We thank both reviewers and the editor for their valuable comments. We reply to these comments below:

Answers to RC1 comments:

Figure 5.20.: Left: Volumetric flow normalized by injection rate into target aquifers through the fault zone. **Right:** Salt flow into target aquifers through fault zone.

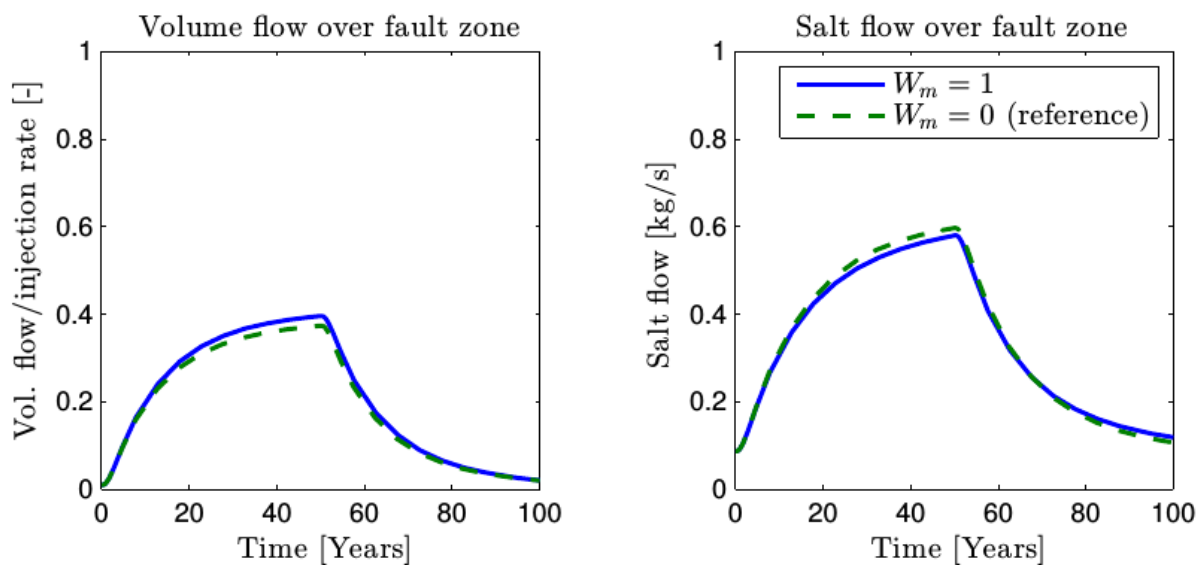
RC1: Mesh too coarse at fault zones. Any grid resolution study? Have you done a grid effect study to test if you capture the right effects? What did you find?

Answer:
We have used a discrete fracture model for describing the fault zone, therefore we are able to assign a fracture width, permeability and porosity. We have conducted a grid convergence study for discretization sizes and fault zone parameters similar to the problem presented in this paper with the analytical solution by Zeidouni (2012) and found that 300x300 m was sufficient for determining volumetric leakage rates (see attached excerpt of Kissinger 2016, DISS_Kissinger_Discretization.pdf Sec. 5.4.1). This grid convergence study was done without considering variable-density flow effects.

Our horizontal grid resolution is constant at 300x300 m, while our vertical resolution is smaller and varies between 10 and 160 m depending on the layer. The fault zone has a width of 50 m. This resolution is of course a compromise between accuracy and computational feasibility. Although we did not perform a grid convergence study for salt transport, we have looked at the effect of salt transport with different fault zone volumes and found it to be not very large during the injection when advective forces dominate, at least when compared to other uncertainties within the

The effects of salt transport: The implementation of the discrete fracture model is such that per default a part of the degree of freedom's (DOF) volume is from the fracture and part from the matrix surrounding the fracture. We have looked at the effect when we neglect the matrix part of the volume at the DOF. This results in a reduced volume at the DOF and therefore a decreased DOF porosity (only fracture volume is active) and an increased transport velocity of the salt water being pushed upwards by the injection. This volume reduction can be as high as a factor of 6 (depending also on fracture and matrix porosities). We have attached a figure describing this comparison from the dissertation Kissinger (2016), see below. Please note that in the figure the „reference" case is not the reference case in this manuscript but the Wm=1 case corresponds to the reference case in this manuscript. Here, we provide a short summary of the results for more details please consider Kissinger (2016). What we see is that, as expected, the salt transport into the shallow aquifers increases for the reduced porosity case (only fault zone porosity) compared to the default case (matrix and fracture porosity considered at the DOF). The overall volumetric leakage is also reduced, which is a result of the increased weight of the fluid column inside the fault zone, eventually leading to an increased resistance against upward flow. A similar behavior of increasing resistance and lower total mass-flow rates due to brine being pushed upward in an improperly sealed abandoned well is reported by Birkholzer (2011). However, the increase in salt transport and the decrease in volumetric leakage we observe for our scenario are rather small.
